Docket Item # 2
BAR CASE #2006-0161

BAR Meeting
March 28, 2007

ISSUE: New residential building
APPLICANT: Anna Maria & Michael Dechert
LOCATION: 804 Pendleton Street
ZONE: RB Residential

Figure 2 - Proposed plan

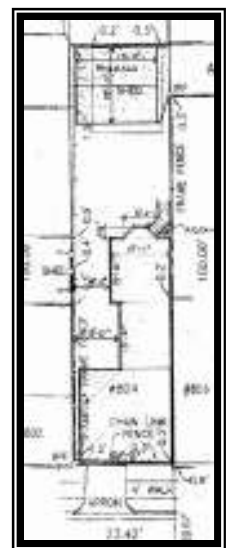
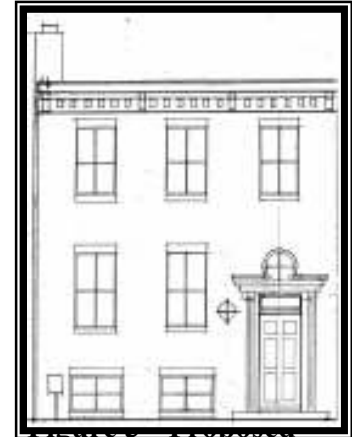
The proposed house will be composed of three sections. The front block is square in plan. It will abut the house at 806 Pendleton Street on the west side and extend across nearly the entire width of the lot and leaving 11" between the wall and the property line on the east side. The narrower middle section will be rectangular in plan. It will also abut the house at 806 Pendleton Street on the west side and will be set back 11' from the east property line. The rear section is wider than the middle section and square in plan. It will be set back 8' from the east property line and will extend beyond the house at 806 Pendleton Street on the west side. The house will be 55'4" long. The heights of the various sections of the house have been reduced and revised following the City Council hearing. The height of the house will be 24'10" high at the front block (reduced from 28'10") and will step down in height thrice with the middle section being approximately 24'1" (reduced from 27'1"), the rear section now proposed to be 23'4" (reduced from 25'10"), and the bay 22'10". The house will be two stories with a raised basement and a flat roof (the

mansard roof previously shown has been deleted). It will be constructed of CMU. The main block of the house will be clad in brick on the north (front), east (side) and south (rear) facades. (A brick sample will be made available to the Board at the hearing.) All other facades will be stucco. There will be wood trim, wood windows, wood doors and round metal down spouts and half round metal gutters. The windows will be simulated divided light windows by Pella, Kolbe and Kolbe or equivalent. The window sills and lintels in the brick clad block will be brick soldier courses. The sills and lintels in the stuccoed portions will be projecting masonry with stucco finish.

front (north) elevation

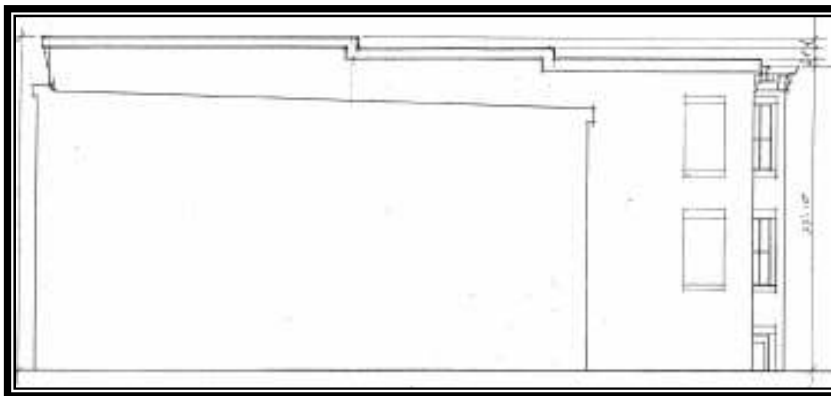
The front (north) elevation will appear as a two story house with a full flat roof and raised basement. The front door will be on the right side of the elevation at street level. The door will be a four-panel door as shown on the detail sheet, rather than six panel. It will be set within a heavy door surround with a rectangular transom and an oculus window above. A globe shaped, surface mounted light fixture will be located to the left of the door. A single step brick stoop will lead to the door. There will be two, four-light windows to the left of the door lighting the basement level, which will be partially below grade. As revised, the basement windows will be at grade and will not have window wells. The first story will have two, two-over-two windows to the left of the door. These windows will be approximately 5.5' in height. The window height will be slightly less in the second story where there will be three evenly spaced two-over-two windows. There will be a wood cornice with brackets and dentils at the base of the flat roof. The cornice will extend around all but the west elevation. There will be a gutter across the front and downspouts at either corner. The electrical meter will be located just above grade at the left side of the front elevation.
